2.0 SITE CHARACTERISTICS

Chapter 2, "Site Characteristics," of the Turkey Point Units 6 and 7 combined license (COL) final safety analysis report (FSAR) addresses the geological, seismological, hydrological, and meteorological characteristics of the Turkey Point Units 6 and 7 site and vicinity, in conjunction with present and projected population distribution and land use and site activities and controls.

2.0.2 Summary of Application

Figure 2.5.1-13. Profile 20 as interpreted from Kula, 2014.

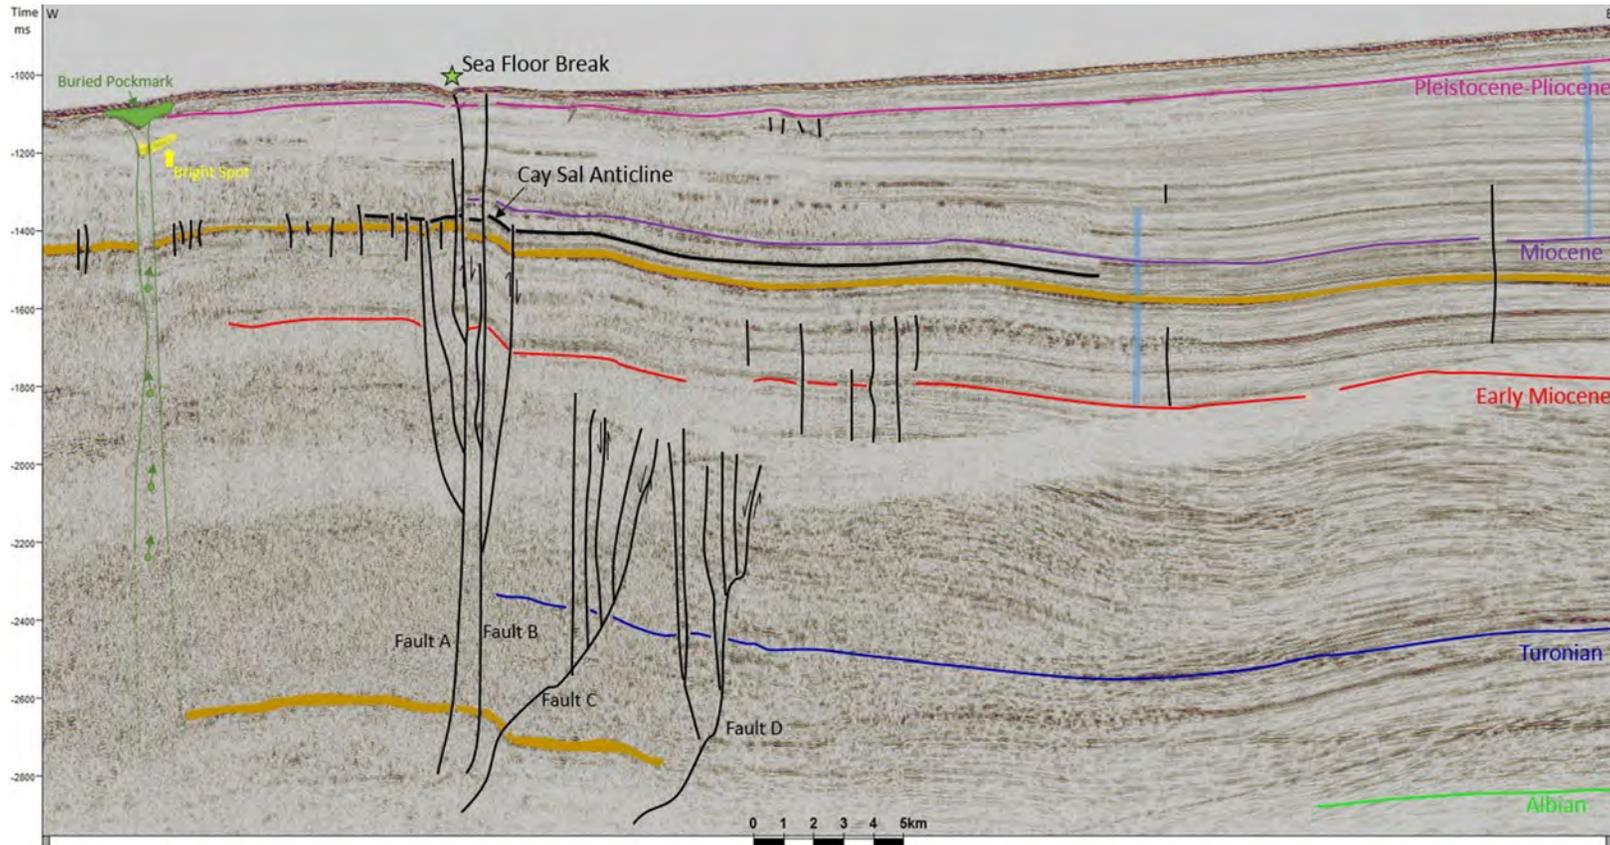
The staff reviewed Kula (2014) and notes that the author includes interpretations regarding possible Quaternary tectonic faults along the western bank of the northern Santaren Channel (northeast of the Cay Sal Bank). High resolution seismic reflection, multibeam bathymetry and sub-bottom parasound profiles reveal Quaternary-aged tectonic structures in the Santaren Channel and the Straits of Florida within about 50 mi of the Turkey Point Units 6 and 7 site (Figure 2.5.1-13). Although there is no seismicity in the area beneath Cay Sal Bank and the Santaren Channel, distinct seafloor scarps suggest recent and significant displacement on faults imaged on seismic reflection. In RAI 81, Question 02.05.01-34, the staff asked the applicant to discuss and integrate these tectonic features into the regional tectonic setting for the Turkey Point Units 6 and 7 site. The staff asked the applicant to provide an analysis of how a northward extension of the Cuban Fold and Thrust Belt terrane with associated Quaternary fault displacement and seafloor scarps on at least two faults impacts the site seismic hazard assessment and seismotectonic boundaries. The staff also asked the applicant to update interpretations of the Santaren Anticline

Based upon all the material that the staff reviewed related to this question, the staff decided to conduct its own seismic hazard sensitivity analysis. The applicant provided a synopsis of Kula's (2014) interpretation of four tectonic faults along the eastern margin of Cay Sal Bank, and her interpretation that these faults represent an extension of the Cuba Fold and Thrust Belt a few hundred kilometers farther north and east than previously mapped by others. Kula suggests neotectonic activity on two of these faults (Fault A and B) along the eastern margin of Cay Sal Bank and north to the Straits of Florida. Kula (2014) interprets that the faults extend in length

Figure 14. Fault Maps of Cuba Showing Earthquakes from the Project Phase 2 Earthquake Catalog (Sheet 1 of 3) (Turkey Point Units 6 and 7 COL FSAR Figure 2.5.1-368). Multiple sources used to compile this map, including Turkey Point Units 6 and 7 COL FSAR Refs. 439, 448, 492, and 494.

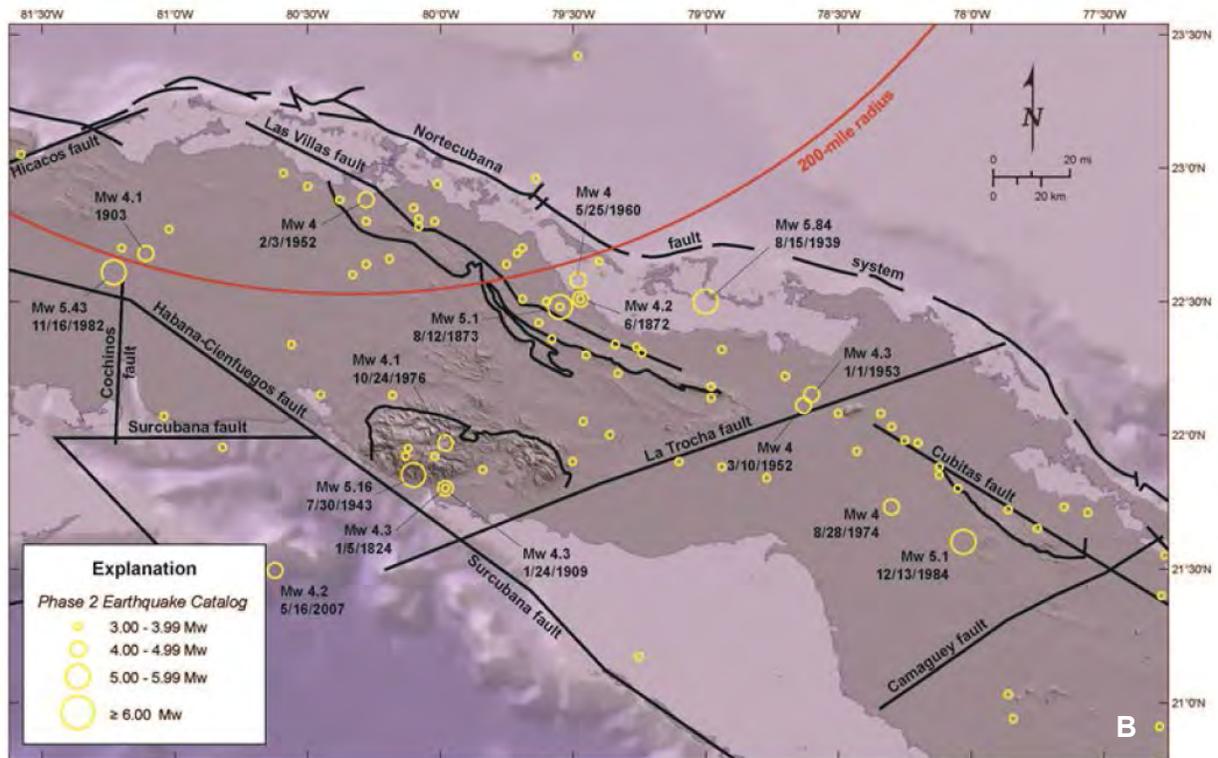
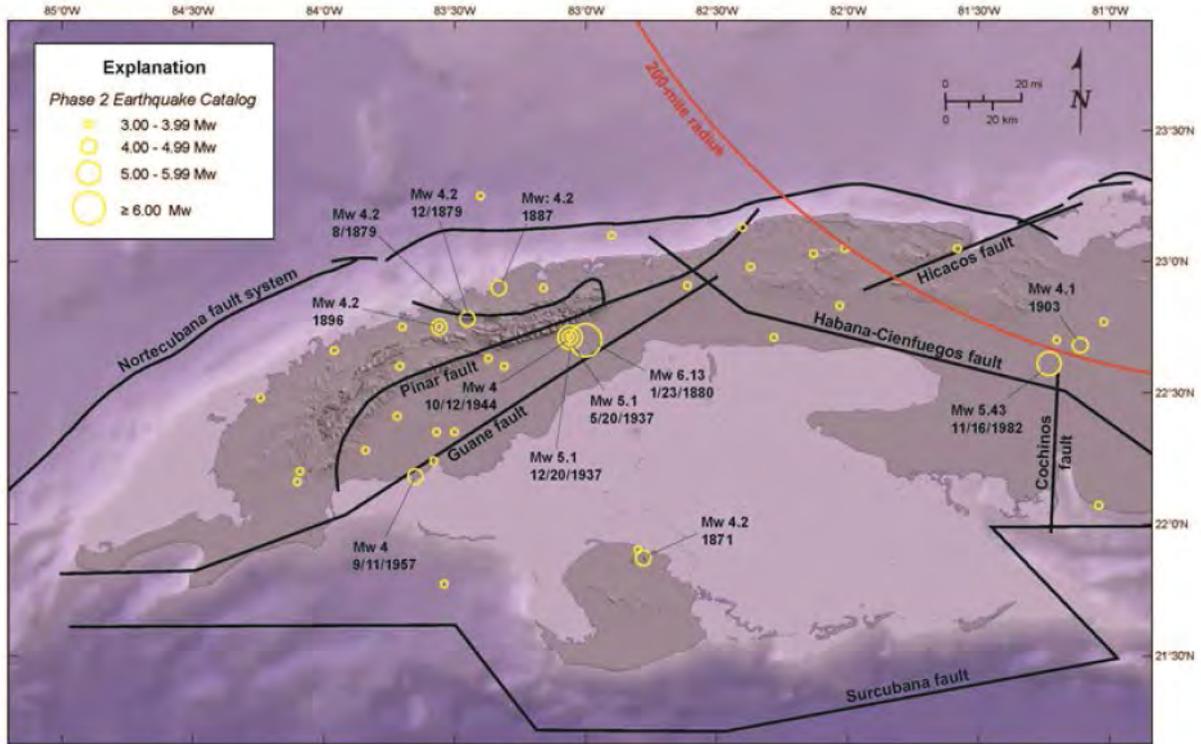
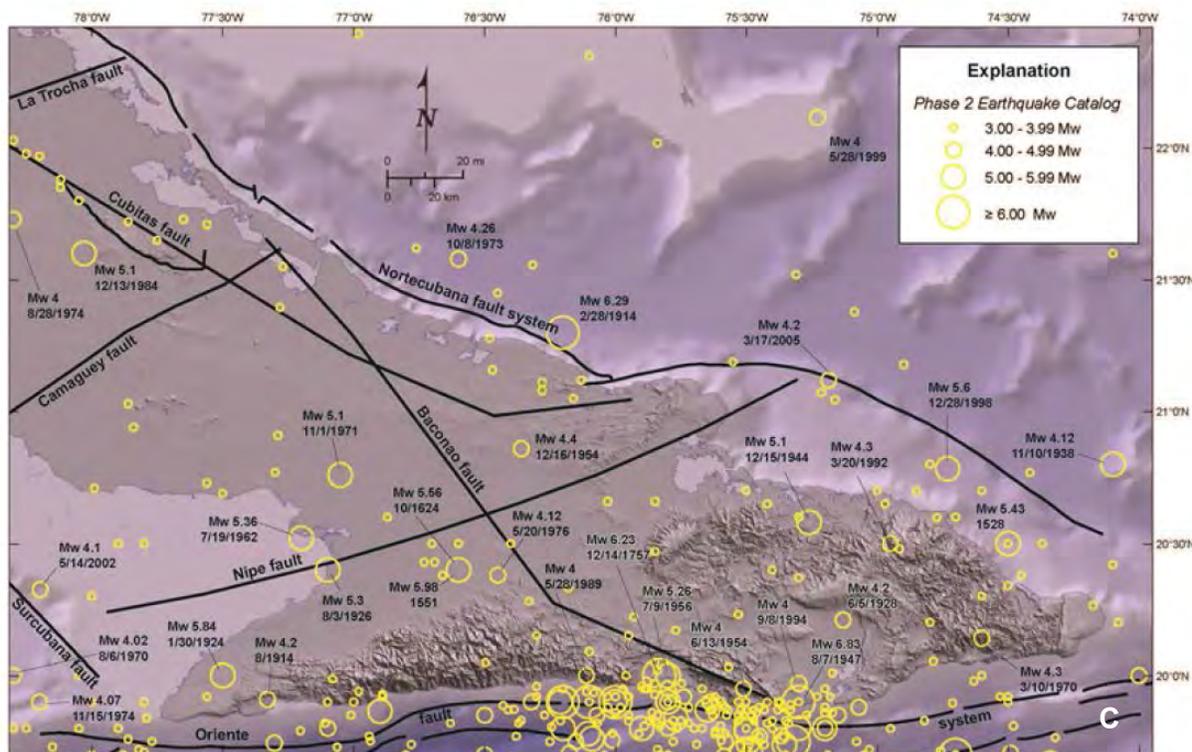
In response to several RAIs regarding Cuba faults and seismicity (RAI 41, Questions 02.05.01-21, -24 through 30) (ADAMS Accession Nos. ML14282A078, ML14282A079, and ML14282A079) dated October 3, 2014, the applicant made a general statement that the lack of permanent seismic recording stations in Cuba, especially for lower-magnitude earthquakes, limits the accuracy of earthquake locations; that earthquakes in Cuba do not appear to correlate strongly with faults; and the Phase 2 earthquake catalog was used to consider the possibility of seismicity associated with a specified fault (Figure 2.5.1-14). The staff notes that the Phase 2

In a June 8, 2015 response to RAI 81, Question 02.05.01-35 (ADAMS Accession No. ML15160A574) the applicant responded that a declustered or mainshock Phase 2 earthquake catalog was used to compute recurrence parameters for the Cuba seismic source characterization. The applicant agrees with the staff that in the Cuba region that mapping seismicity before the declustering earthquake process could be used in identifying potentially active, previously unidentified structures, if the earthquake association were unambiguous. Therefore, the applicant revised FSAR Figure 2.5.1-368 (Sheets 1 through 3) to include mainshock events of Mw and above 3.0, and foreshocks, aftershocks, and cluster events of Mw and above 3.0, and all small events mainshock and dependent events of Mw less than 3.0. The applicant also stated that the relevant text in Turkey Point Units 6 and 7 COL FSAR Section 2.5.1 will be revised accordingly. The applicant also stated that while the majority of the small-magnitude (Mw less than 3) seismicity is scattered and diffuse, seismicity patterns do show several clusters that are not part of the Phase 2 mainshock earthquake catalog Mw of 3 and above. Some of these earthquakes are not of sufficient size and definition to merit their consideration as fault sources. Other earthquake clusters are near faults that were included in a PSHA sensitivity study of the modeling of Cuba as a seismic source. The applicant concluded that when specific faults were considered as alternatives to the Cuba seismic source, they produced negligible impact on the total seismic hazard at the Turkey Point Units 6 and 7 site, as compared to the modeling of Cuba as a single areal seismic source zone (see FSAR Section 2.5.2.4.4.3.4.2.1). The staff evaluates the sensitivity analysis for the Cuba seismic source in RAI 41, Question 02.05.01-21 and RAI 5896, Question 02.05.02-4. Staff considers the revised Turkey Point Units 6 and 7 COL FSAR Figure 2.5.1-368 showing the total earthquake catalog of independent and dependent earthquakes sufficient response to this question and thus considers RAI 81, Question 02.05.01-35 resolved.
